CITY OF ALBUQUERQUE

PLANNING DEPARTMENT – Development Review Services

RE: **Kiddie Academy**
Grading and Drainage Plan
Engineer's Stamp Date 11-14-2016 (File:C19D061)

GRADING & DRAINAGE PLAN

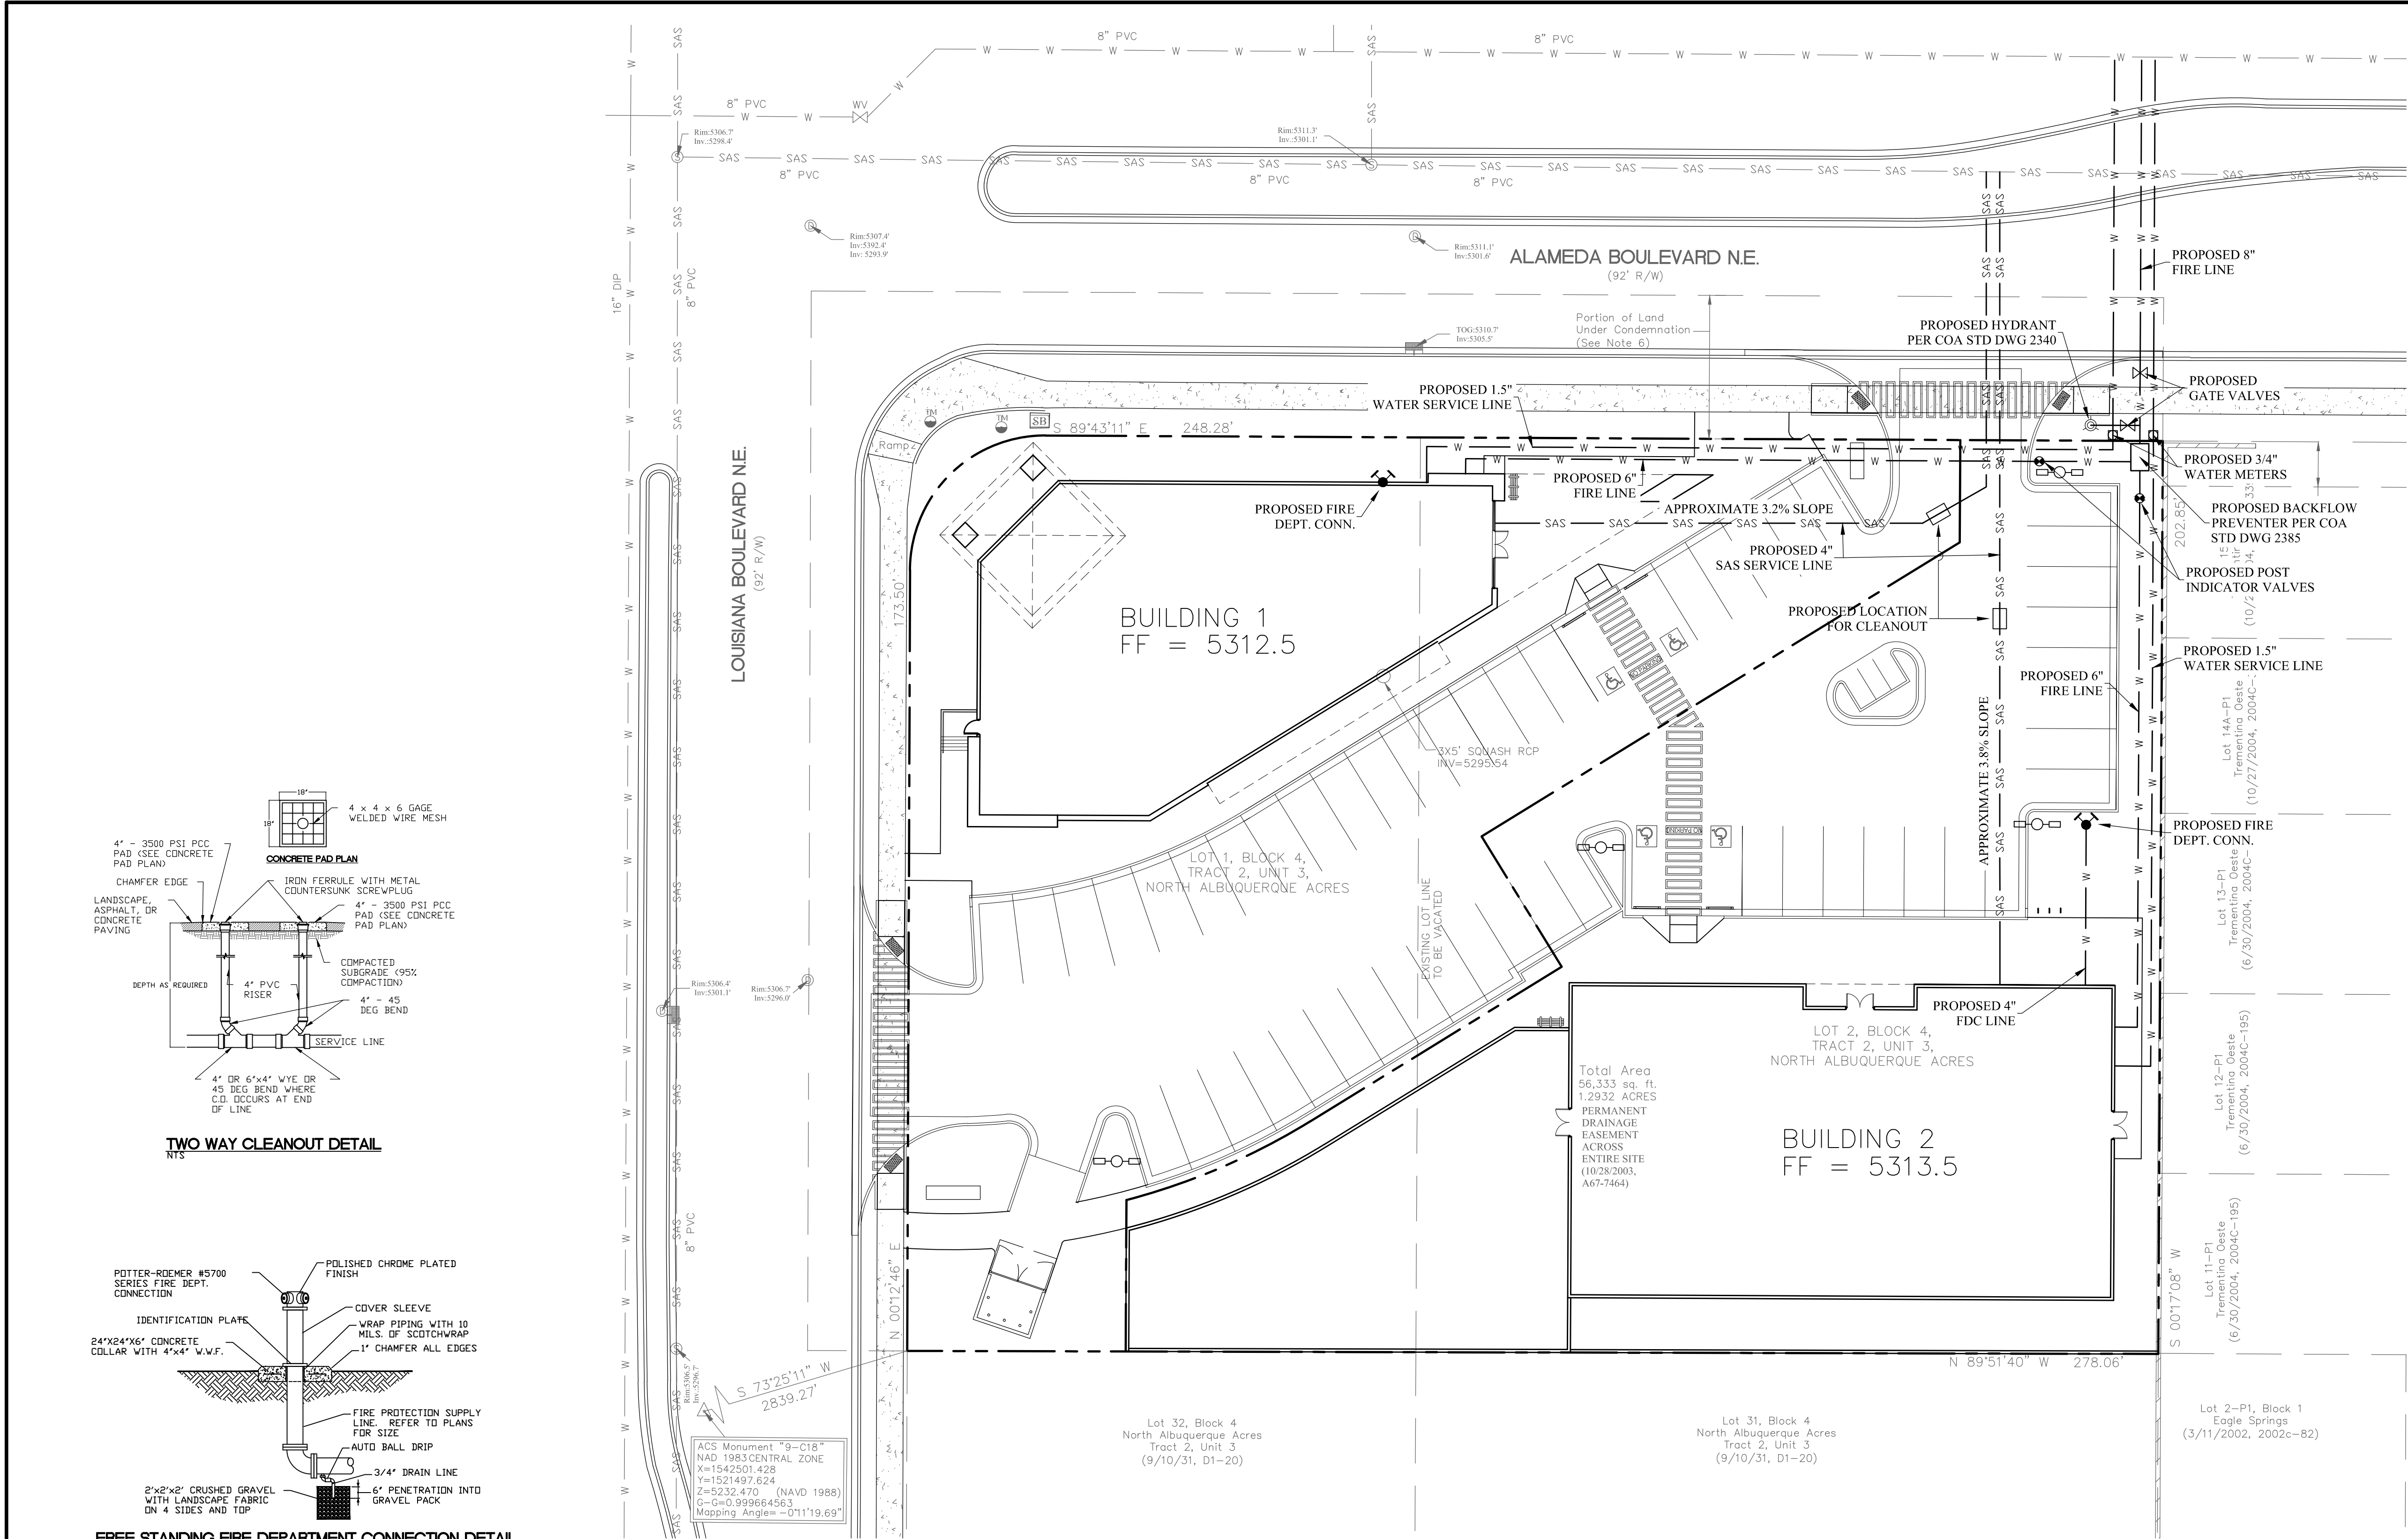
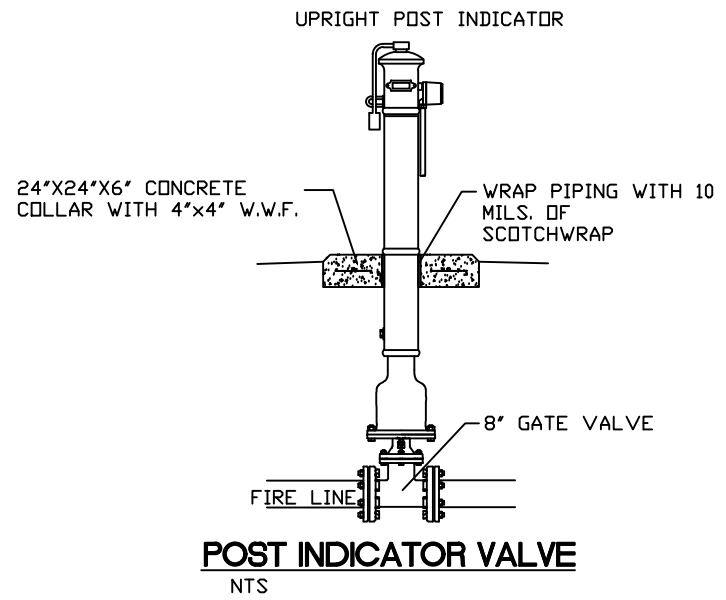
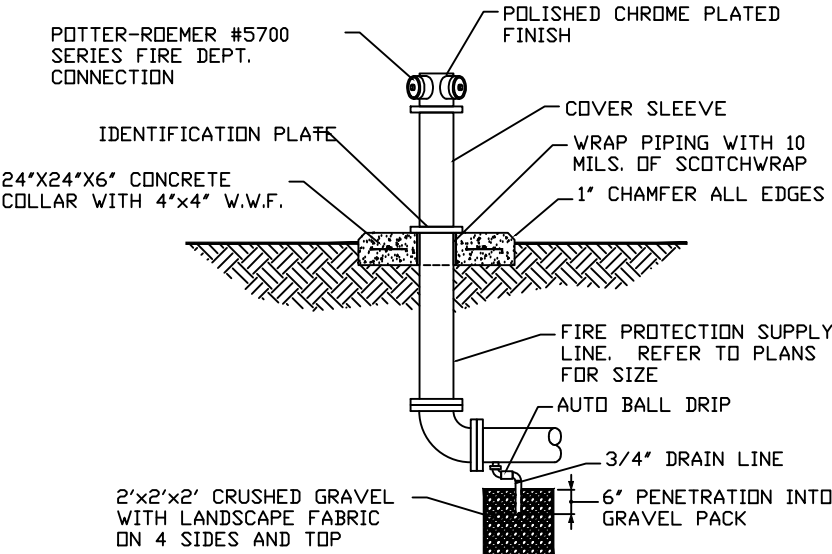
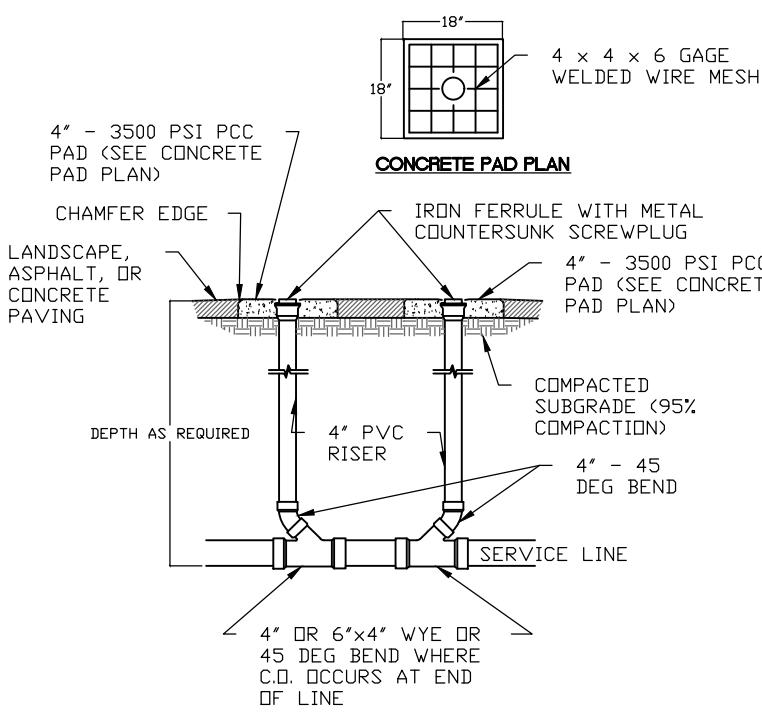
Based upon the information provided in your submittal received 11-15-2016, the above-referenced Grading and Drainage plan is approved for Building Permit. Per today's DRB hearing (#1010997), the Plan is also approved for Site Plan for Building Permit and Site Plan for Subdivision. Furthermore, the Plan is approved for SO-19 Permit, with the following condition:

1. The Contractor will need to follow the Standard SO-19 Notes (see attached). Please ensure that they are followed; the City will need to inspect the work within the Right of Way.
